# Heels in VAE Switches

Audience	Main Points	Change History
Corridor/Delivery Managers Team Managers Work Group Leaders Project/Delivery Engineers Engineering Compliance Managers	New VAE switch design Old design has hidden dowel pin New switch WON'T fit Switch replacement requires switch AND stockrail replacement Plates require replacement	Adopted from RailCorp CTN 06/10

The heel arrangement for VAE tangential switches has changed.

Figure 2 Old VAE switch design

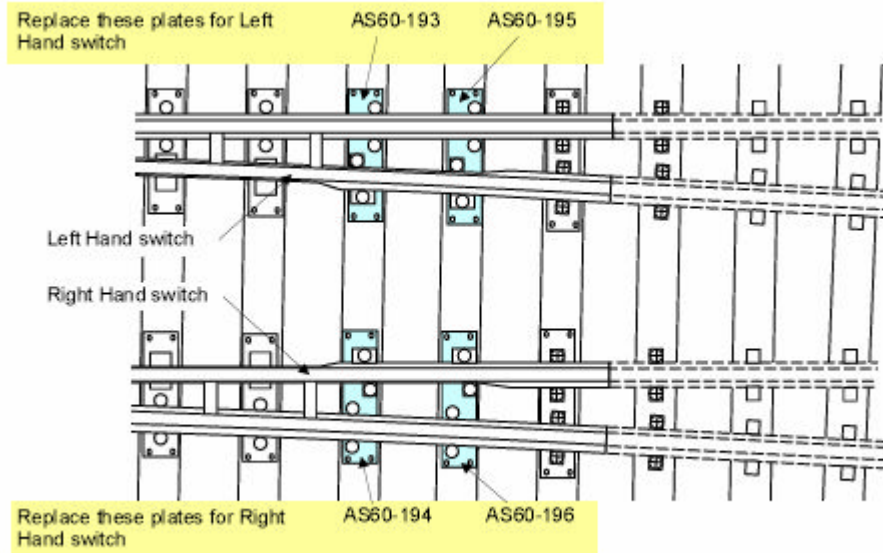
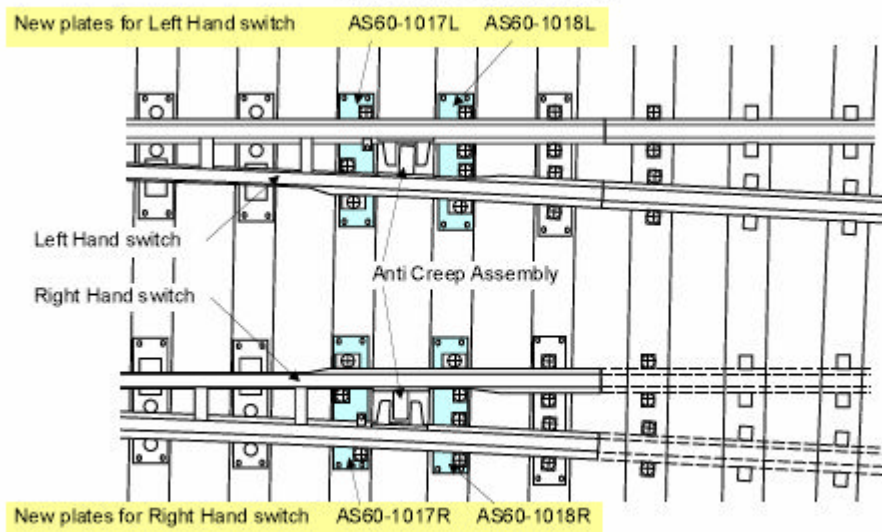
The older design does not have anti creep chocks that join the mainline and turnout rails in the heel area. Restraint for the switch rail in this design is provided by a hidden dowel pin that sits in the plate and recesses into the underside of the rail foot. The older design can be identified by noting the absence of any kind of visible heel arrangement (See Figure 1 below).

In the new design a heel arrangement is fitted. The plating for this is also different.

When a replacement switch or stockrail is required for the old design a complete switch & stockrail assembly to the new design must be used. The assembly will include the anti creep assembly but staff must separately order new plates for the affected area. These must be installed in accordance with the relevant drawing.

The standard design detail is shown in Figure 2 (old design) and Figure 3 (new design). For other layouts consult the ARTC Standards & Systems department.
